Site Instruction

Project Name:	AQUAVISTA - Bayside	*Project No.:*	8489D
Client:	TRIDEL Corporation	*SI No.:*	E 022
To:	TRIDEL Corporation	*Page No.:*	1 of 2+ 12 attached
Attention:	Chadi Loza	*Office:*	Toronto
Fax number:	-	*From:*	Sunanda Perera Tao Li

Title: Miscellaneous Changes

PANEL SCHEDULE

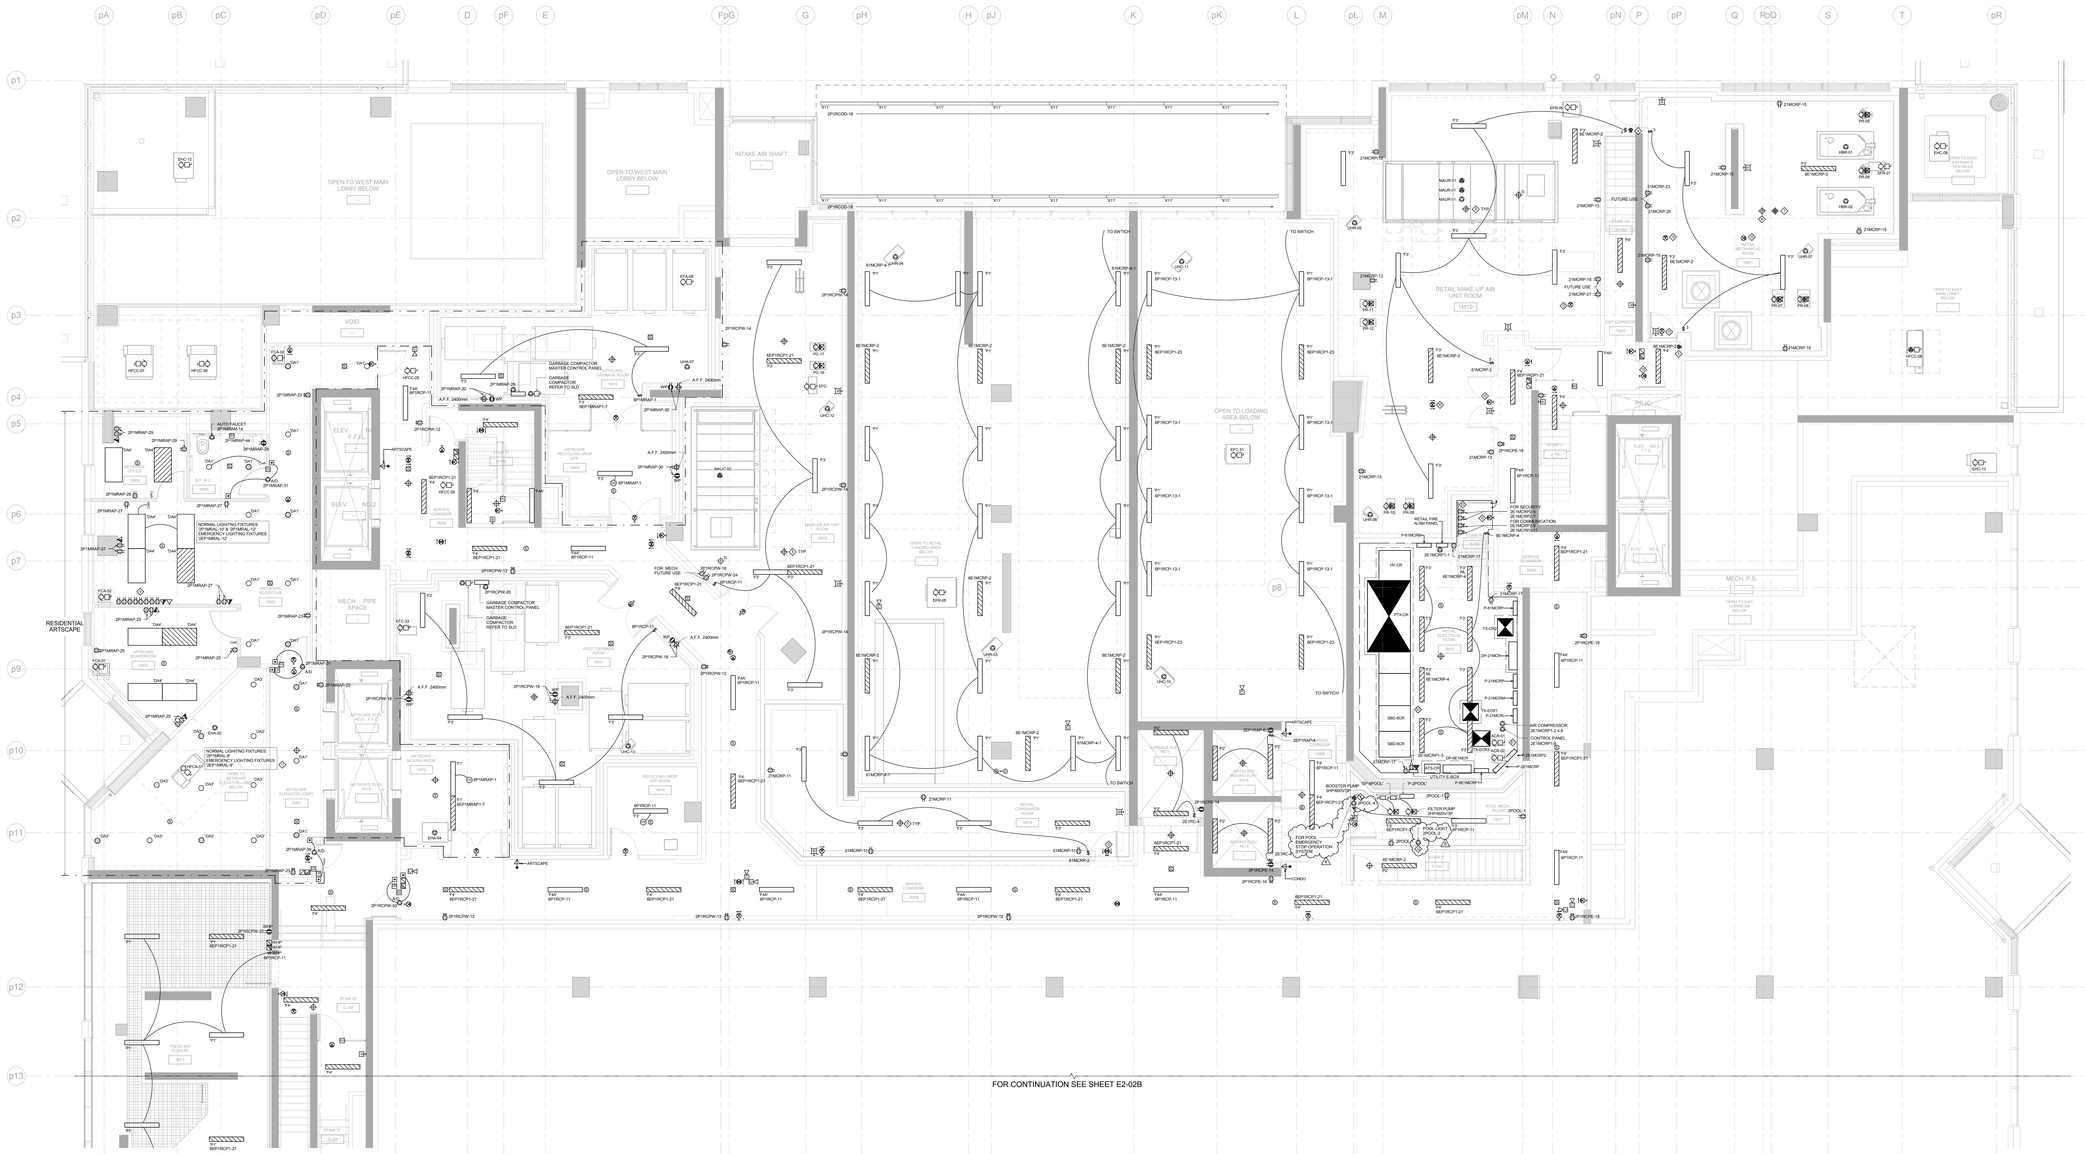
Spec	Issued	Items
Panel 'P-2POOL'	Yes	• Revise one breaker to 15A/1P GFCI type.

Scale	1 : 50
Drawn by	N
Author	
Checked by	
Checker	
Project No.	8489D
Date	03/09/15
Drawing No.	E2-02A

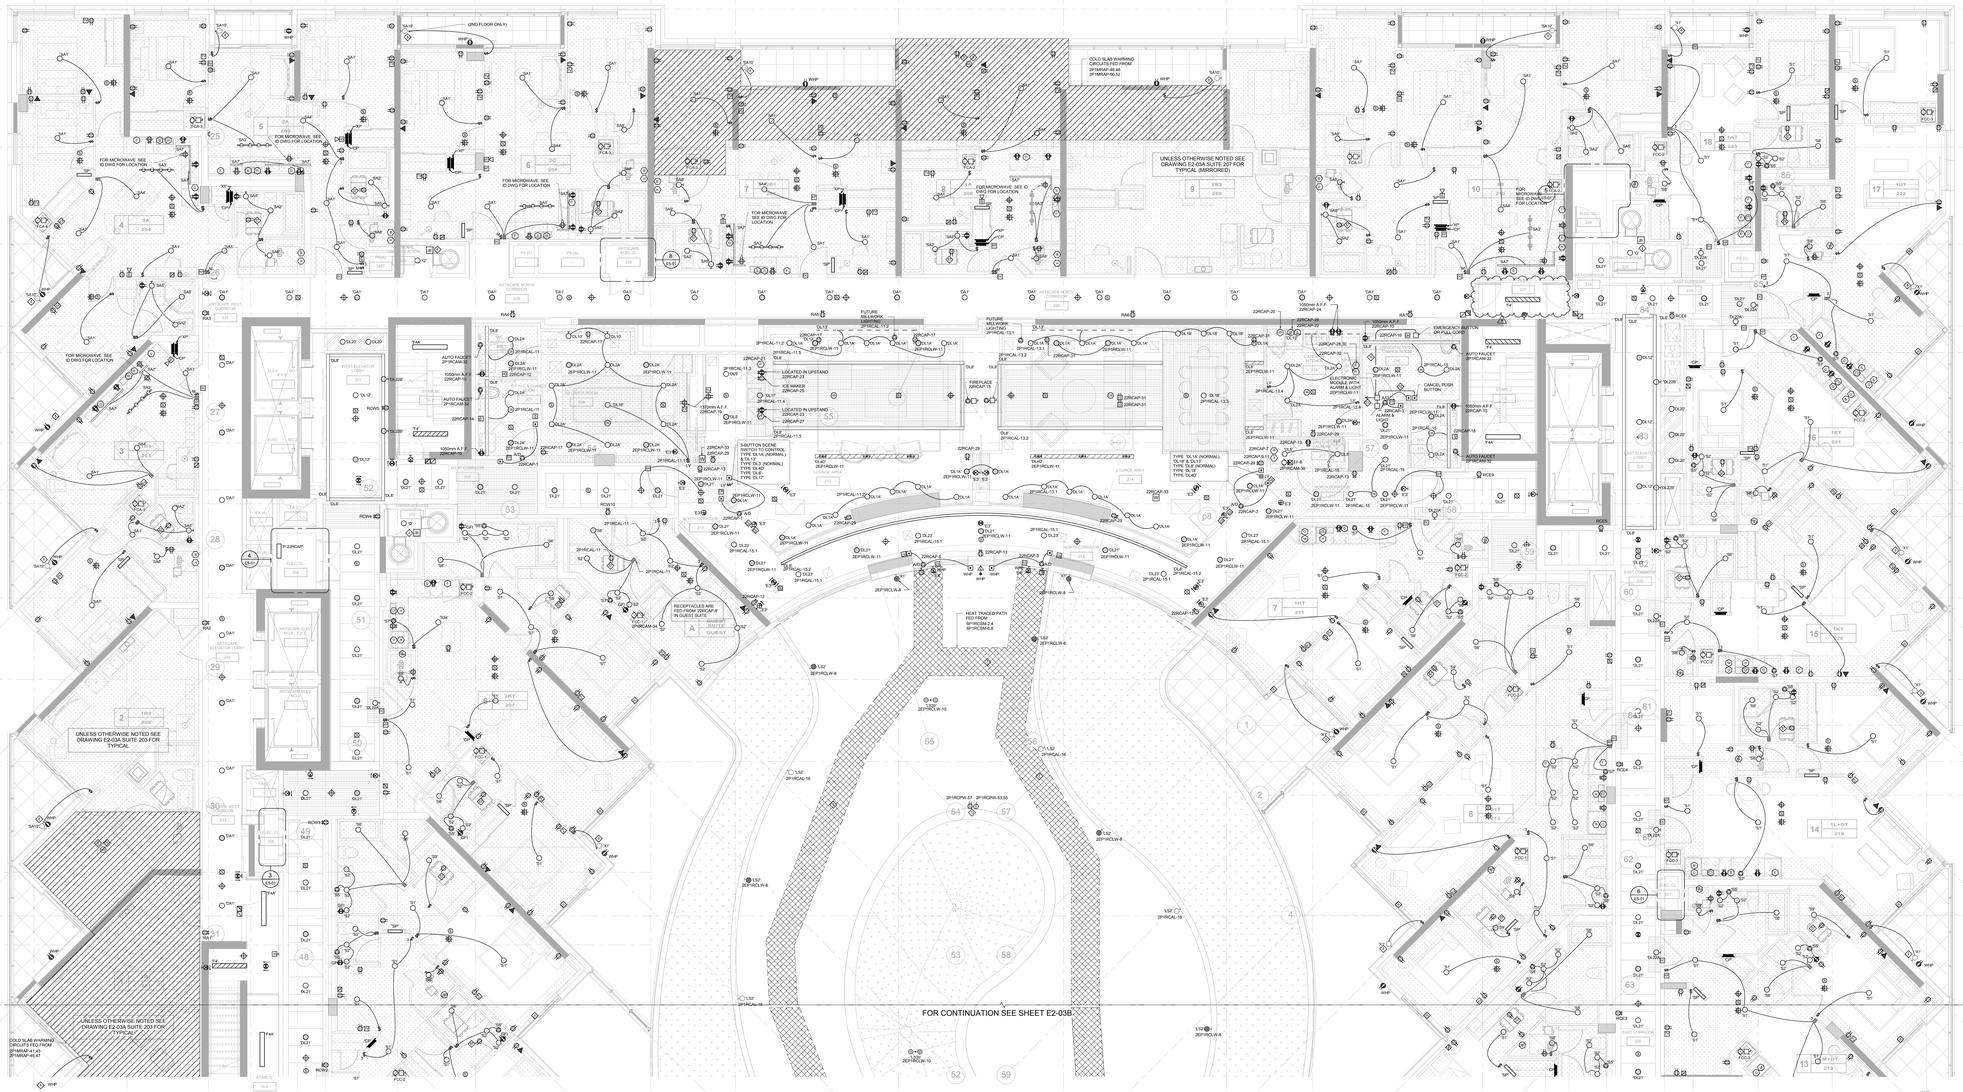
Drawing No.	Drawing Issued	Items
E2-02A	Yes	• Add two power connections for pool light and emergency stop operation system as shown. Exact location to be coordinated on site.
E2-03A	Yes	• Delete type 'DL21' (Qty-2) lighting fixtures and fire alarm smoke detector and strobe in vest (227) as shown. • Add type 'F4' (Qty-1) lighting fixture in vest (227) as shown. Connect this fixture to stair J emergency circuit.
E2-03B	Yes	• Relocate pool electrical devices to pool control station location as shown. • Add junction boxes at pool control station and run conduits back to pool mechanical room for pool light and control wiring as shown.
E2-04A E2-05A E2-06A E2-07A E2-08A	Yes	• Delete type 'DL21' lighting fixtures and fire alarm smoke detectors and strobes in vest (312) (412) (512) (612) (712) (812) (912). • Add type 'F4' lighting fixtures in vest (312) (412) (512) (612) (712) (812) (912). Connect these fixtures to stair J emergency

Scale: 1 : 50
Drawn by: Author
Checked by: Checker
Project No.: 8489D
Date: 03/09/15
Drawing No.: E2-08A

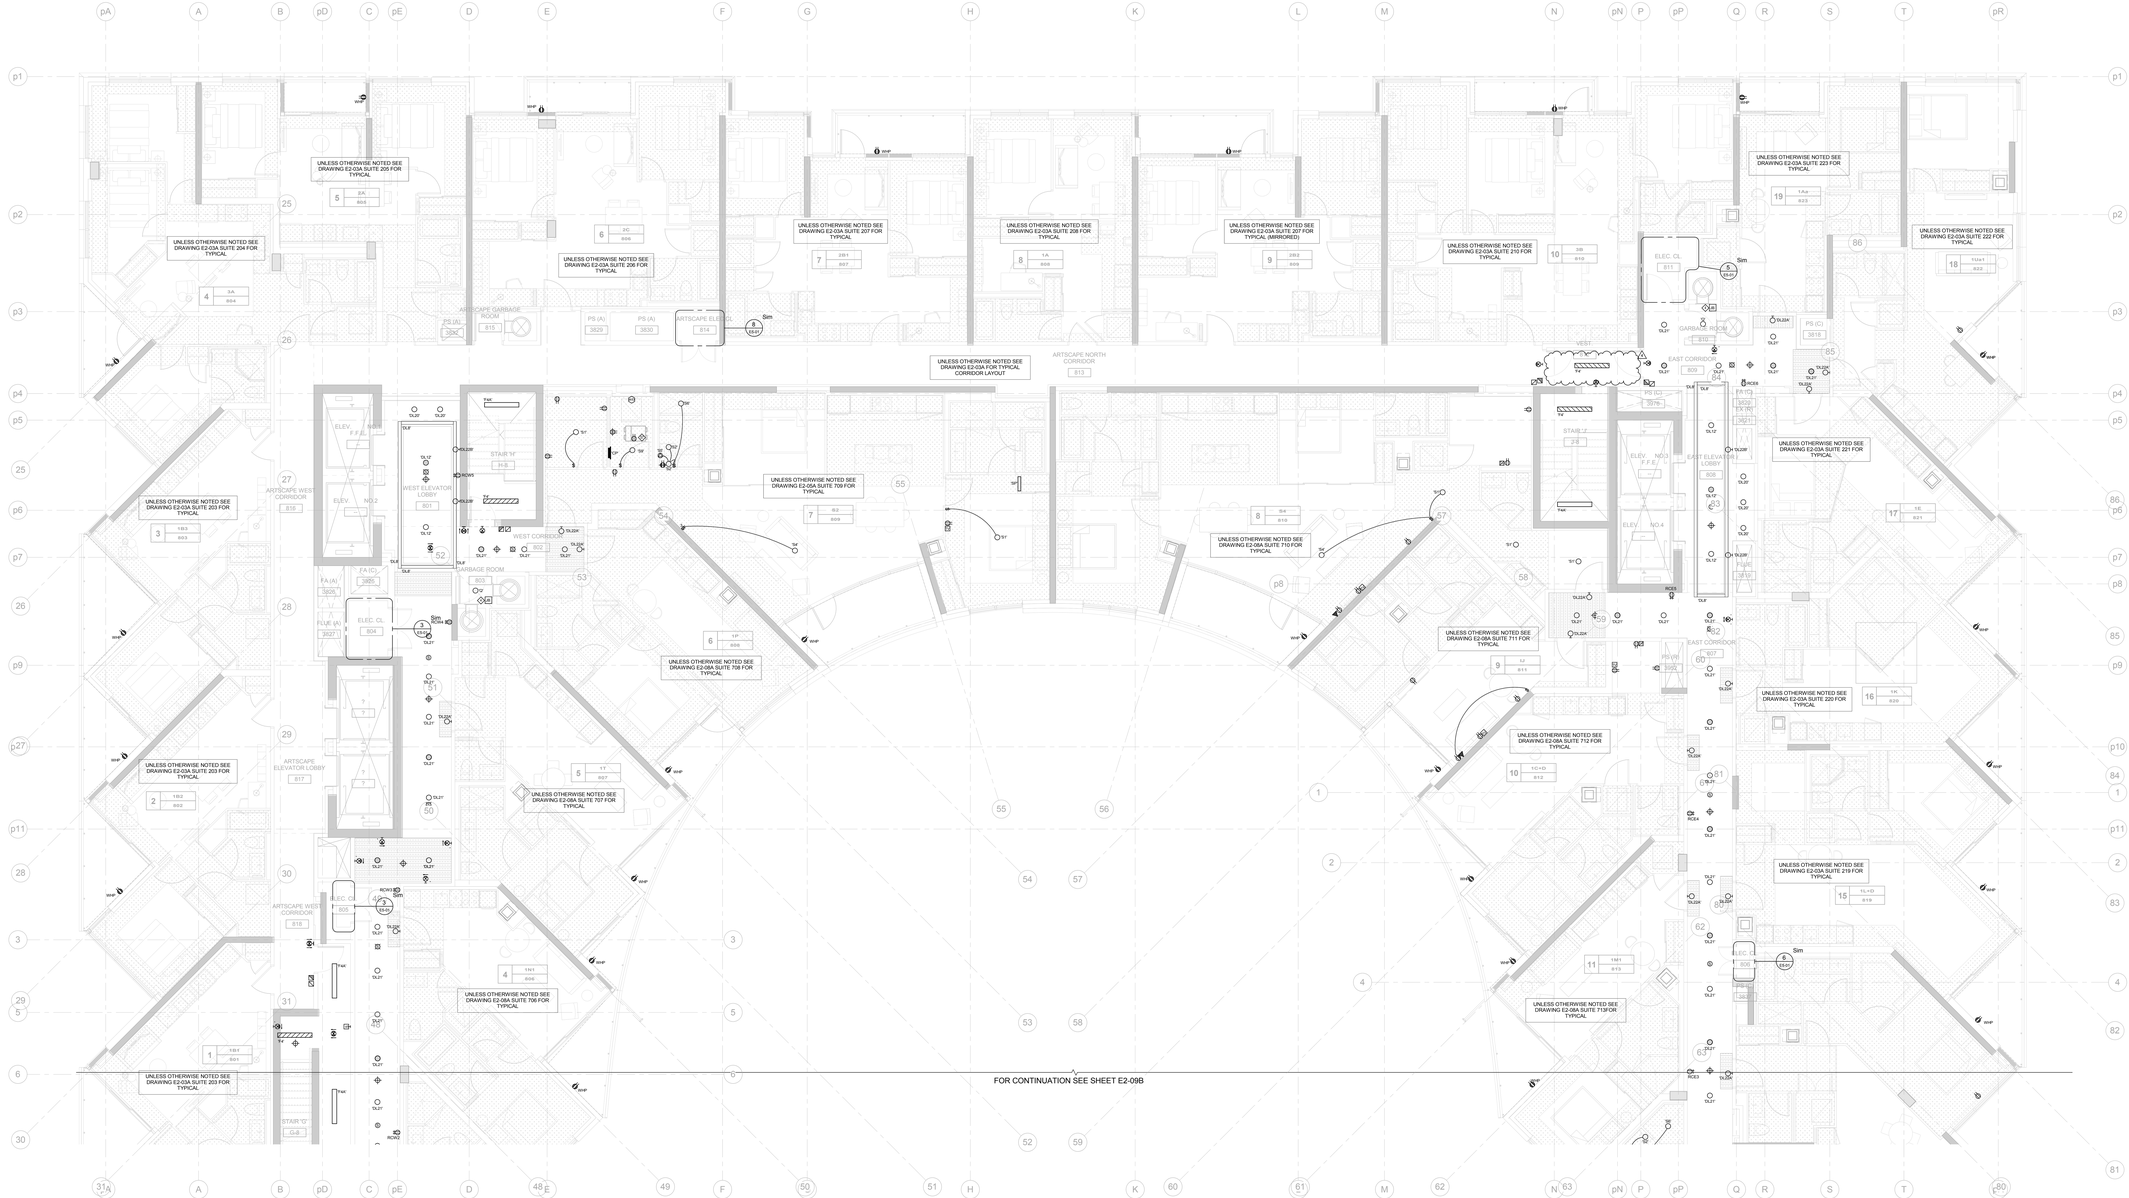
E2-09A E2-10A		circuit.
E4-04	Yes	• Add fire alarm zones to electrical room pre-action system as shown.
